Product / Process Change Notification (PCN)

PCN Number:	PCN_WCAP-FTBP_20241130	Change Category:
Affected Series:	WCAP-FTBP	<input type="checkbox"/> Equipment/Location
Affected Order Codes:	See table below	<input checked="" type="checkbox"/> General Data
PCN Date:	2024-07-30 (YYYY-MM-DD)	<input type="checkbox"/> Material
Effective Date:	2024-11-30 (YYYY-MM-DD)	<input type="checkbox"/> Process
		<input checked="" type="checkbox"/> Product Design
		<input checked="" type="checkbox"/> Shipping/Packaging
		<input type="checkbox"/> Supplier
		<input type="checkbox"/> Software
Contact:	Product Management	Datasheet Change:
Phone:	+49 (0) 7942 - 945 5001	<input checked="" type="checkbox"/> Yes <input type="checkbox"/> No
Fax:	+49 (0) 7942 - 945 5179	Attachment:
E-Mail:	pcn.eisos@we-online.com	<input type="checkbox"/> Yes <input checked="" type="checkbox"/> No

Because of a database mismatch, Würth Elektronik eiSos will update datasheets for the series WCAP-FTBP. In the meantime to increase the production capability, Würth Elektronik eiSos will change the product marking. There will be no change in form, fit, function, quality or reliability of the product.

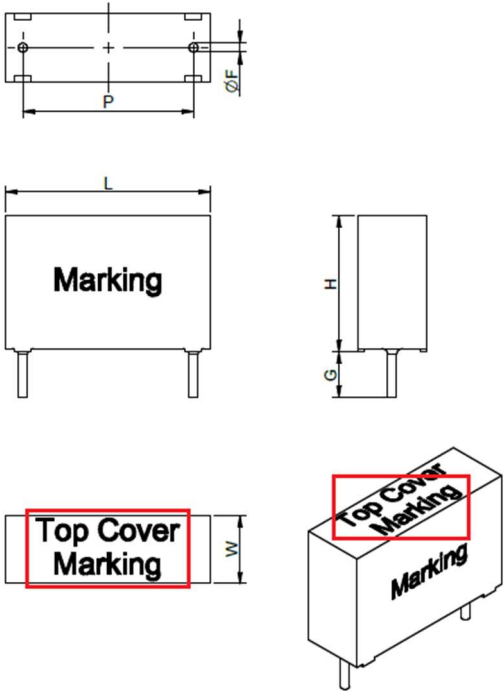
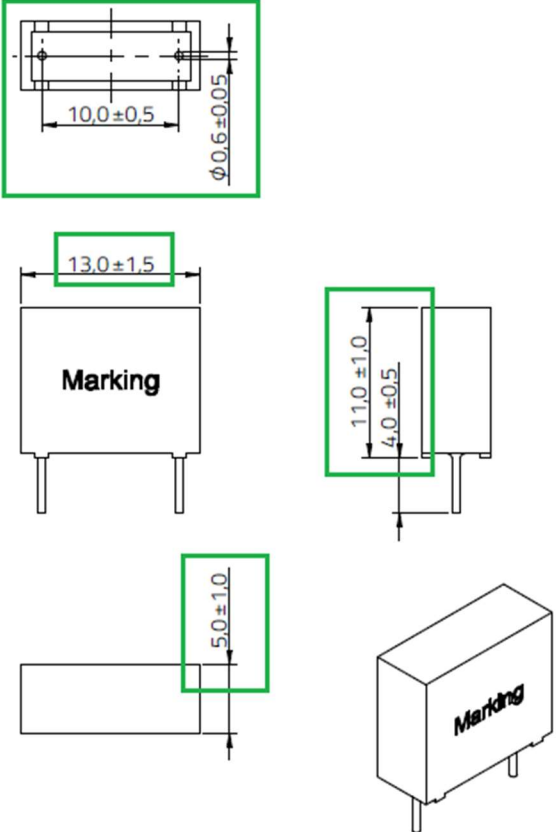
1.1 Würth Elektronik eiSos will update the dimensioning from an **indirect dimensioning** to **direct dimensioning**. The table will be removed and all dimension values will be shown directly in the drawings.

And the "Top Cover Marking" will be removed based on the new marking, details will be explained in 2.
